Airworthiness Concern Sheet

Make, Model, Series, Serial No.: Taylorcraft, all models equipped with landing gear.

Reason for Airworthiness Concern: Failure of the Main Landing Tie Strut, Part Number B-A51

SB NO. 78-001

FIG. 1.

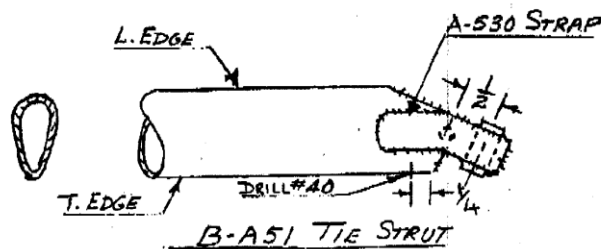
COMPLIANCE PROCEDURE: (1) Inspect landing gear tie strut (TAC P/N B-A51) near "bolt" at axle for obstruction or foreign material in drain hole

Note that drain hole is either located at center of strap (TAC P/N A-530) and/or at trailing edge of tie strut. Only one hole is sufficient for drainage.

(2) If drain hole(s) is (are) plugged, open with suitable means.

(3) If none of the drain holes exist, drill #40 in trailing edge as shown in Fig. 1.
